PROPOSED FLOOR PLANS

PROPOSED CHANGE OF USE OF FIRST FLOOR RESTAURANT INTO DOMESTIC ACCOMMODATION AT 8a BANGOR ROAD, OVERTON, WREXHAM LL13 OHB		
Prepared by: M.A. Clark.	Proposed Floor Plans	Scale 1:100
Tel/Fax: 01691 662749	Plan No: 1716/05MAC (amended) Original Drawing A3

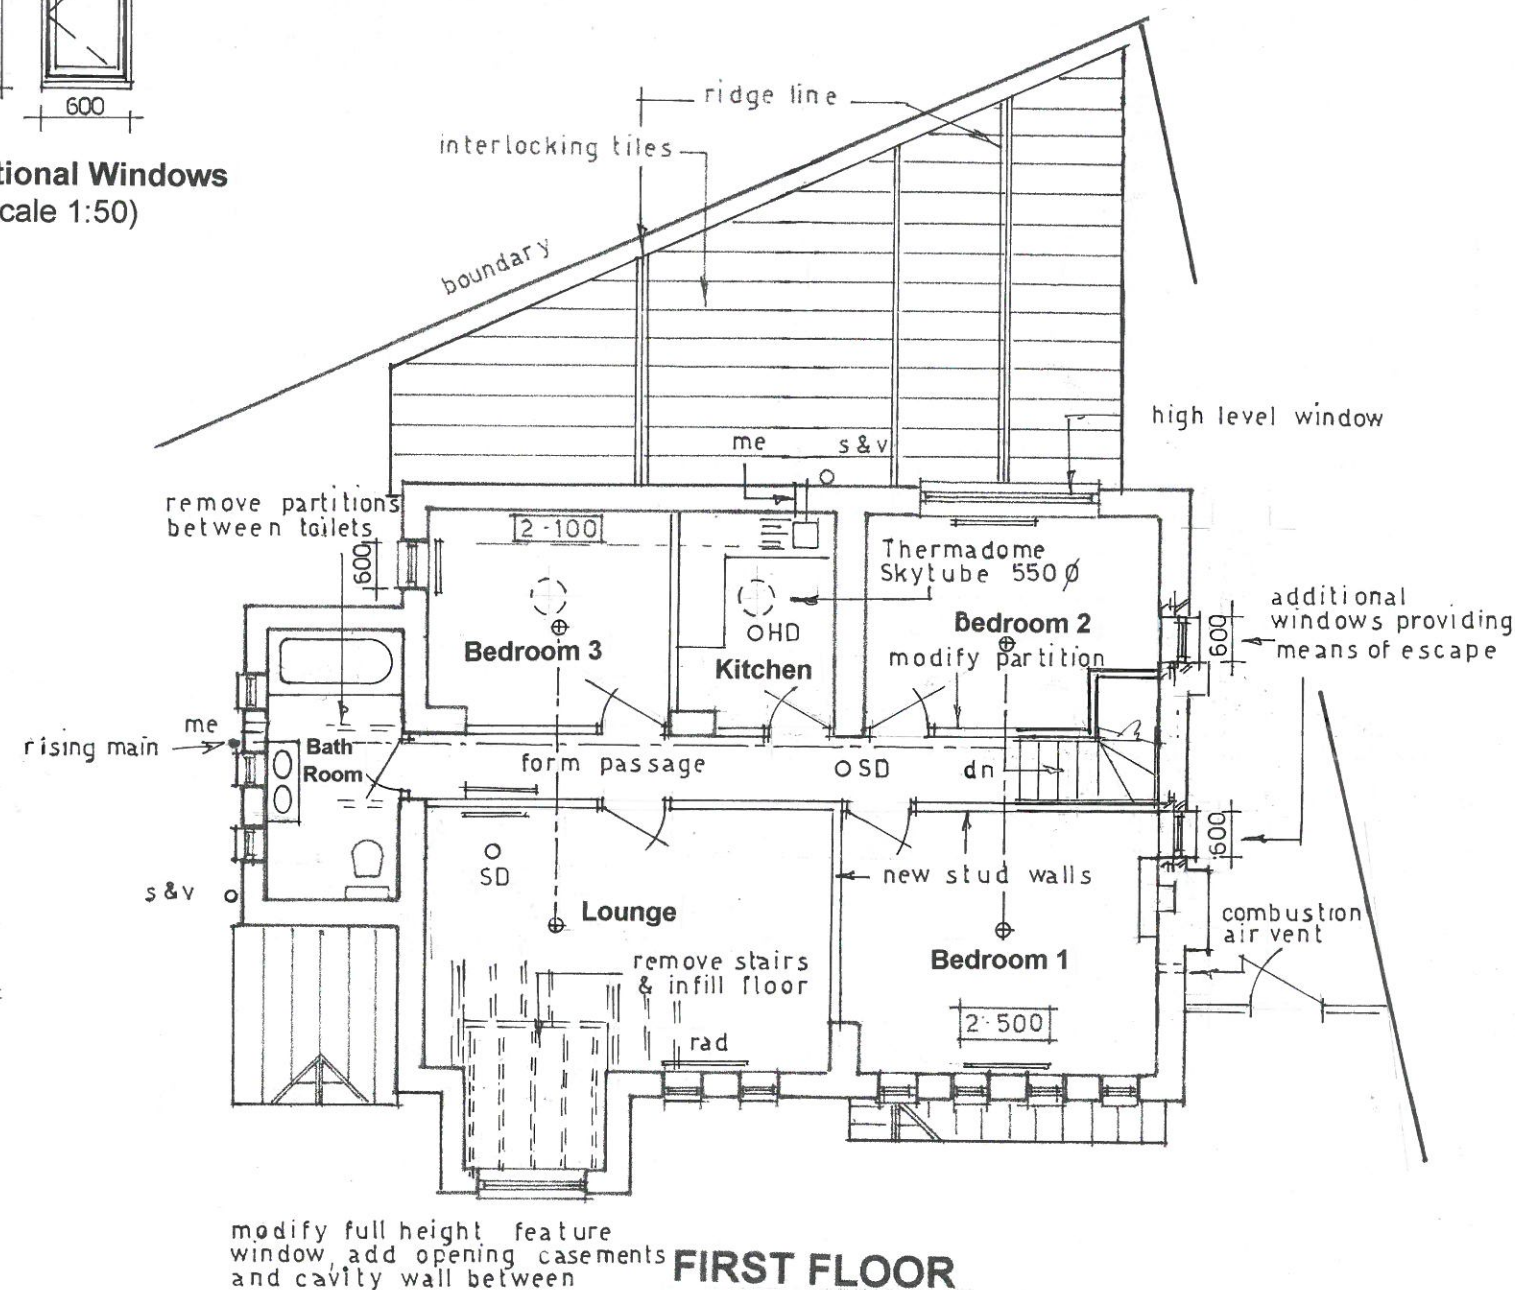
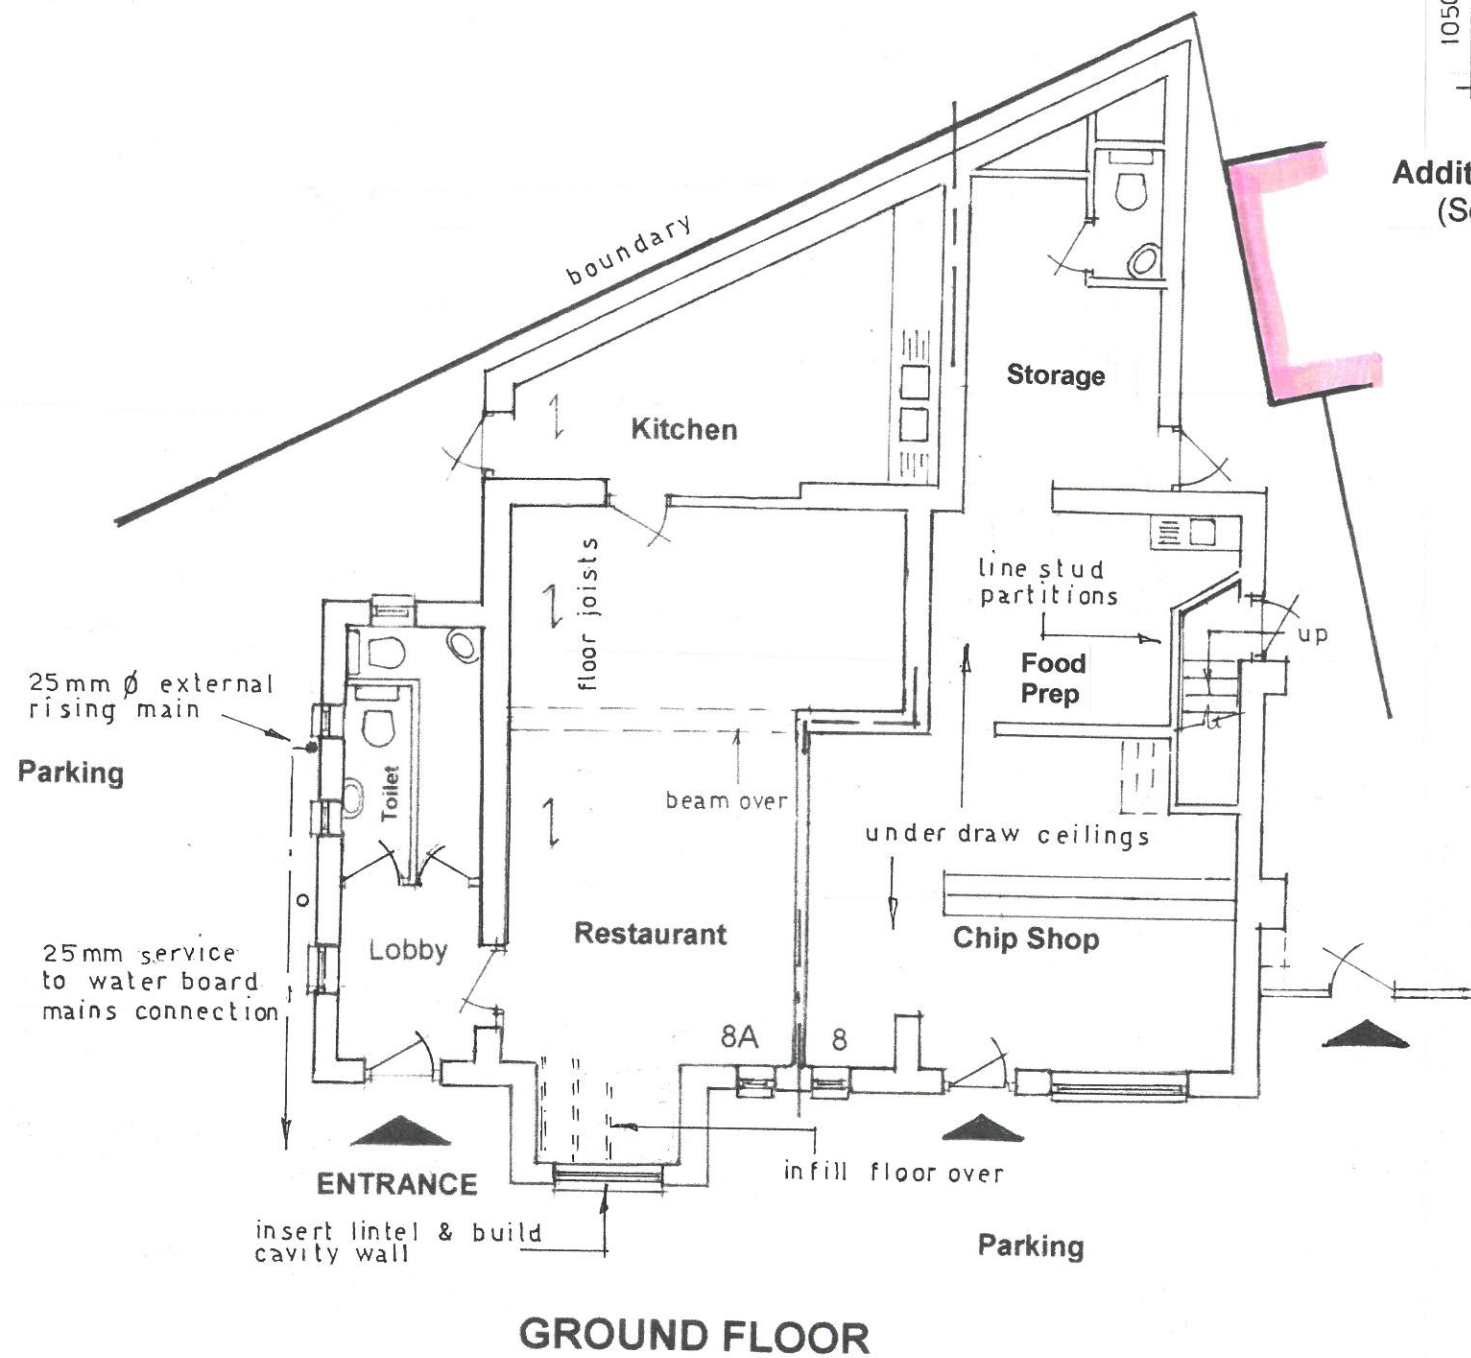
Additional Details Added 8/7/16
 2 in No. means of escape windows in new openings.
 25mm mains water 'rising main' and full sprinkler system.
 First floor covering added to achieve 60min fire protection.
 Heat detector & Smoke Alarm indicated.
 (for full details of the above see Addendum to Specification)
